ADDENDUM

SUBJECT: **Addendum to Item F18a:** Coastal Development Permit Amendment Request No. A-5-VEN-10-138-A2 (ADC Development Inc.), scheduled for the Commission meeting of May 11-13, 2016

STAFF REPORT: PERMIT AMENDMENT

Application No.: A-5-VEN-10-138-A2

ROOF DECK FLOOR PLAN

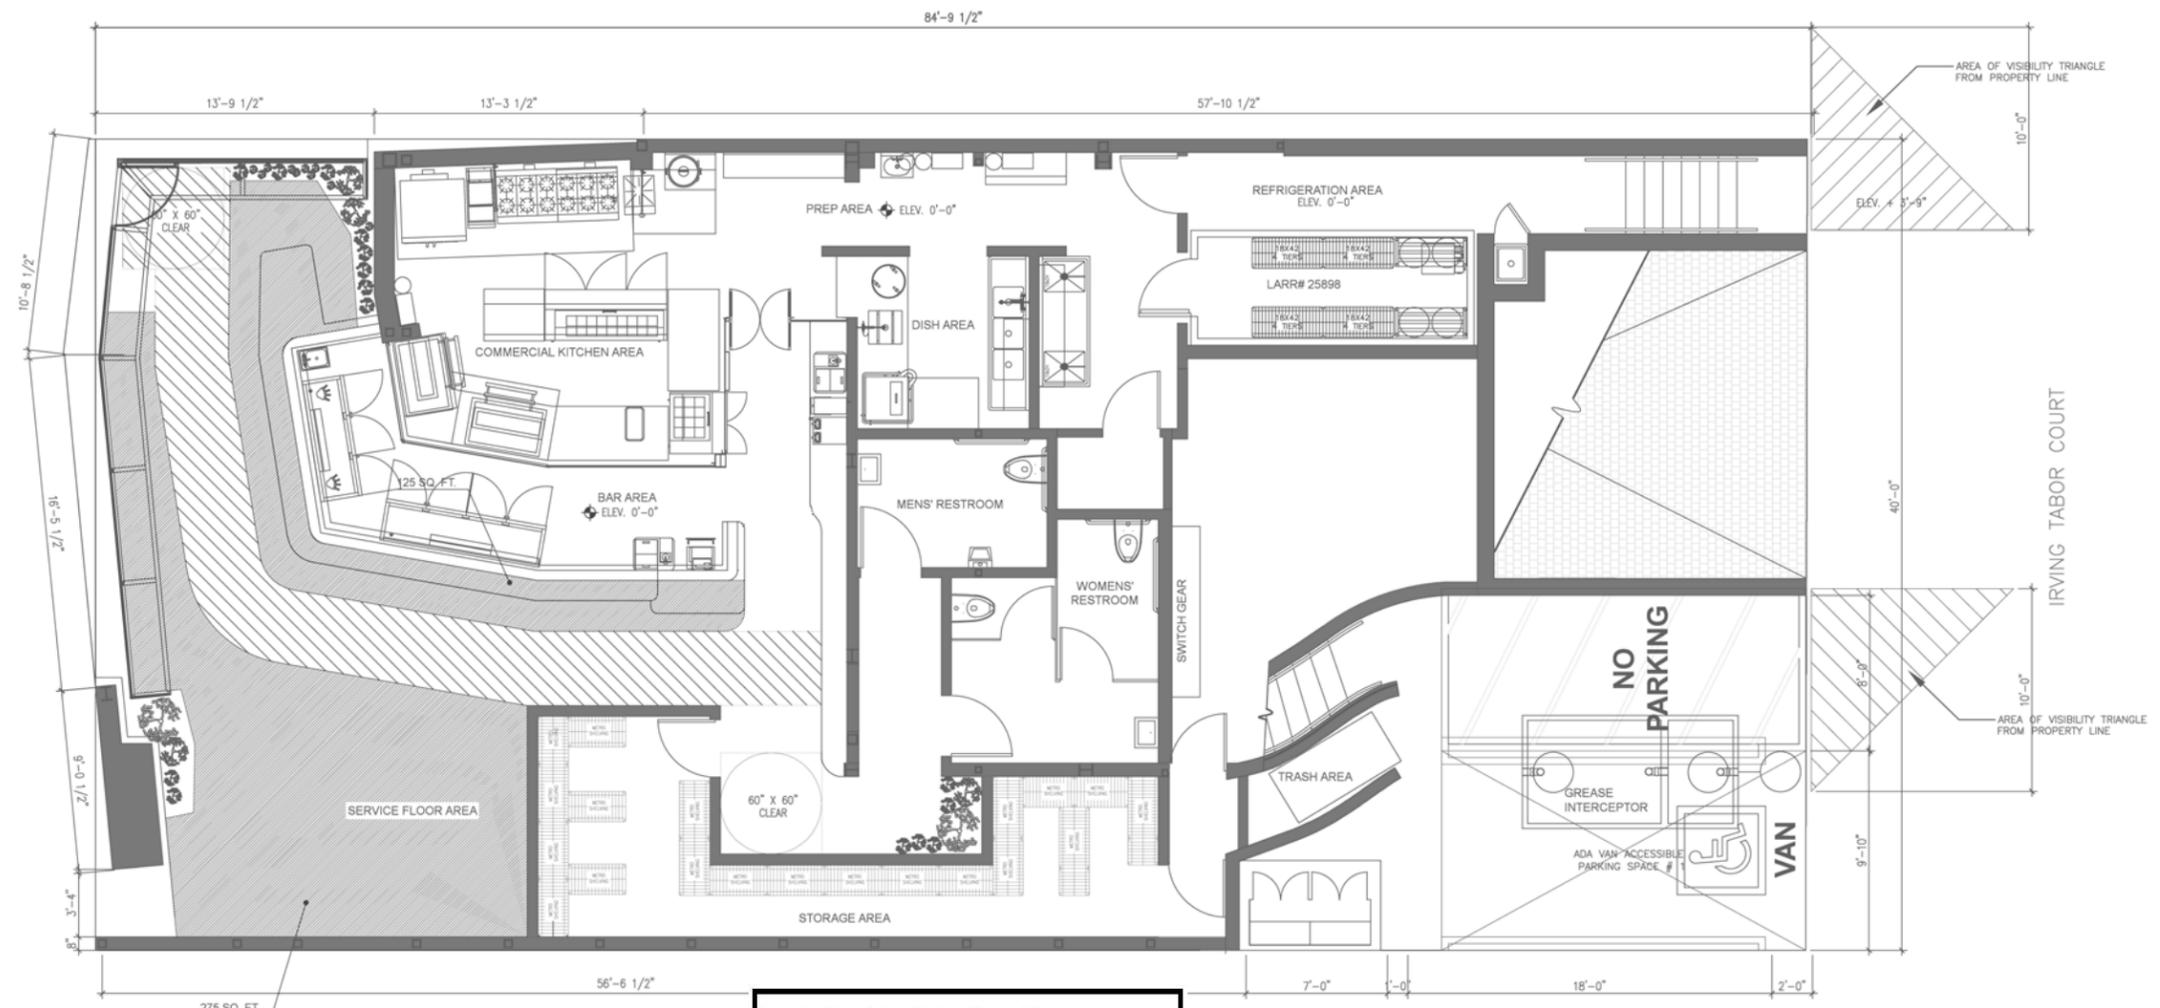
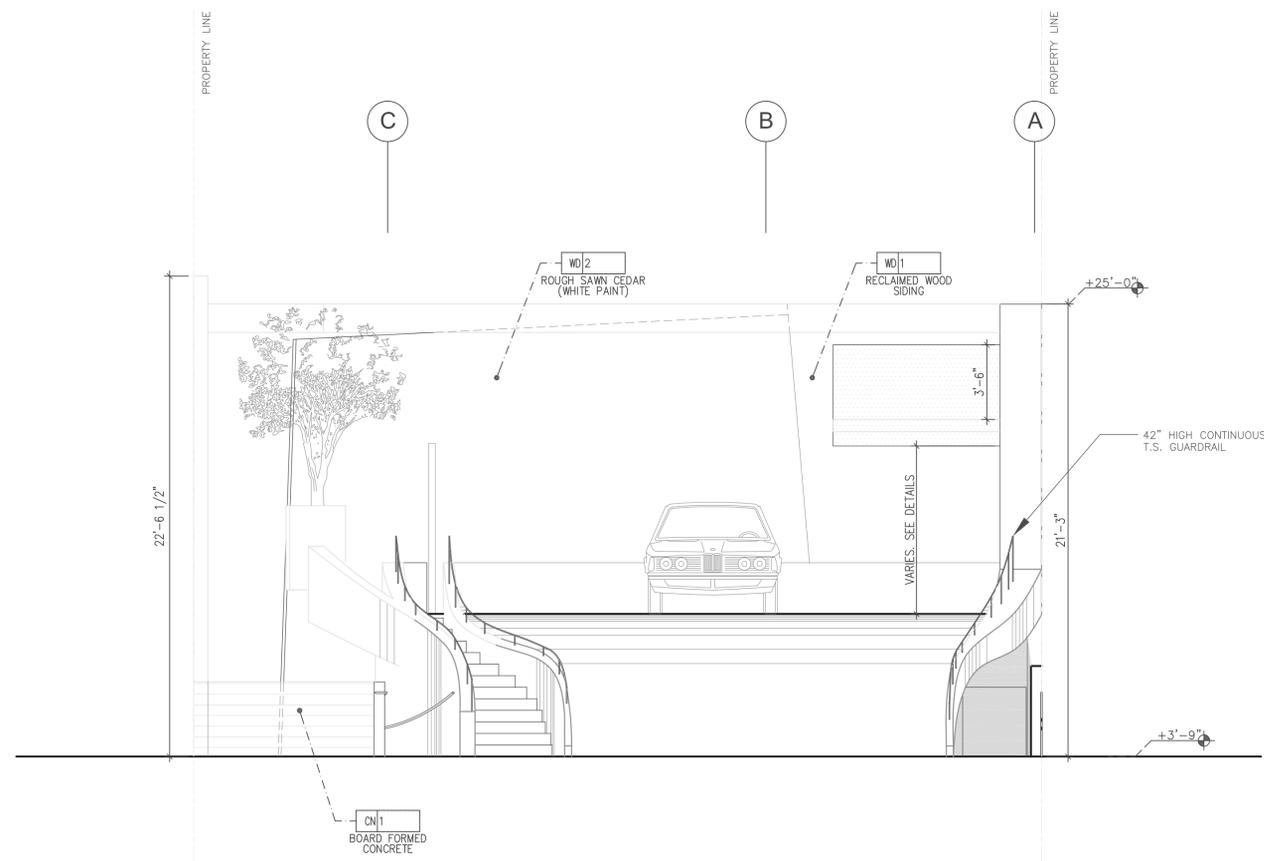
I have no objection to an approval for reduced parking as it would be the amount of spaces required for the smaller restaurant. That is, if the size of the restaurant will truly be as stated in the amendment and no outside restaurant service of any kind will be on the parking deck.

So here we go again. Who is going to enforce the rules when this applicant uses the parking deck for restaurant service? How will they be enforced?

You are aware that the deck has been landscaped and paved in such a way that is obvious it is not a parking area. No one spends that kind of money paving the entire deck with expensive stones for the valets. You are aware that this applicant obtained load calculations from the city for outside heaters. Doubtless, you are also aware that the proposed bike rack locations in front of what will be a totally packed-in tandem parking area are likely impossible to use. Who is going to carry bikes above and past parked cars to place in bike racks and later do it again to return them to the owners? Certainly not the bike users as no one is permitted to park anything on the deck except a professional parking valet.

Coastal Development Permit A-5-VEN-10-138, as amended, does not authorize dining, drinking, temporary seating, or outdoor service of any kind on the rooftop parking deck. The rooftop area shall be used for vehicle storage and bicycle storage activities, as called out on the final approved plans.

On the roof of the approved restaurant, the permittee has called out the required 10 vehicle parking spaces (three rows of three tandem spaces on the rooftop plus one ADA accessible parking space at grade at the southeast corner of the property adjacent to the alley). The vehicle parking spaces will occupy the majority of the rooftop and **Special Condition 2** requires the permittee to guarantee that all 10 parking stalls shall be striped with markings on the hardscape surface, consistent with the final approved plans, to indicate their approved use and location. The permittee's plans show the nine vehicle parking spaces as well as 12 bicycle parking spaces atop the roof (**Exhibit 2**). The permittee has stated that the rooftop will be used for vehicle and bicycle storage and that outdoor dining is not proposed atop the roof.
